From: PLANNING LIAISON AND ESTATES OFFICER Ref. 87/6/1914 HORN CRAGG QUARRY

APPLICATION FOR ESTABLISHED USE CERTIFICATE.

HORN CRAG QUARRY, SILSDEN

HORN CRAG QUARRY - SILSDEN

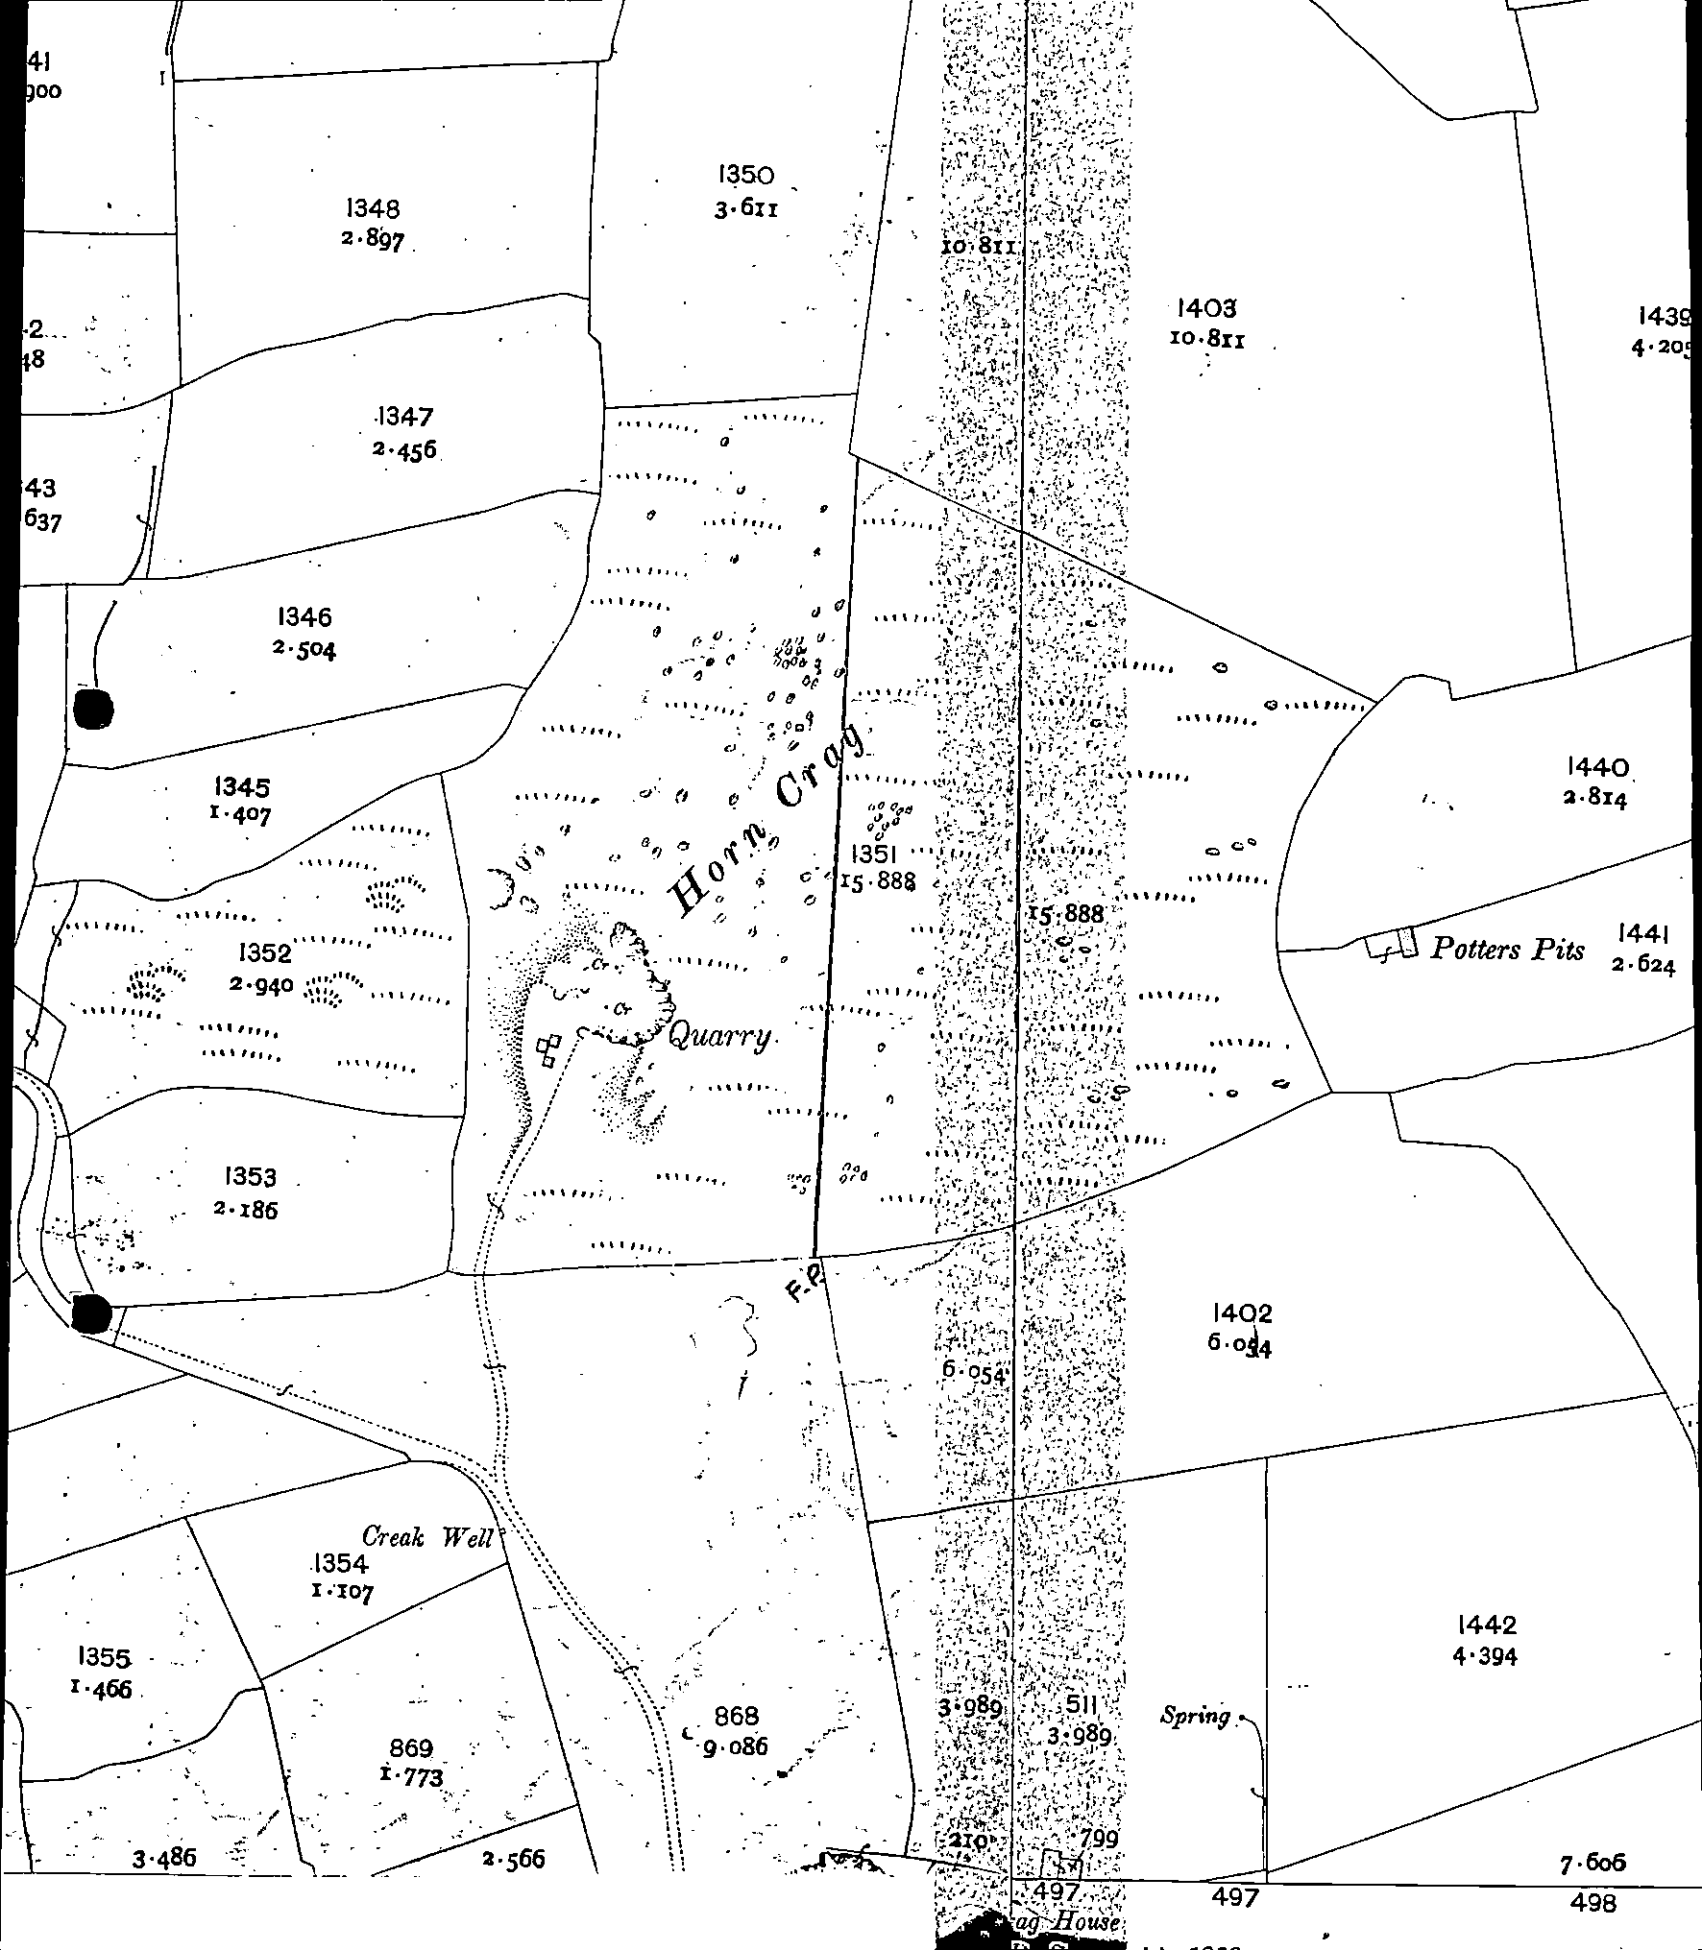
Yorkshire Water apparatus affected by the development are shown on the attached plan. It involves two 900 mm diameter pumping mains and a telemetry cable and the line of the mains runs below the site and across the access road to the quarry.

The applicant has offered to construct a reinforced concrete raft across the line of the main to enable the passage of heavy vehicles. The raft would require supporting piers and would need to be designed and constructed to the satisfaction of Yorkshire Water.

The line of the aqueduct runs close to the quarry and there is some concern with regard to the effect of blasting operations and the resulting ground vibration on the structural integrity of the mains. It is not believed that there is a high risk but the Authority may seek indemnity from the quarry operators for mains failure and any resulting repair and damage liability.
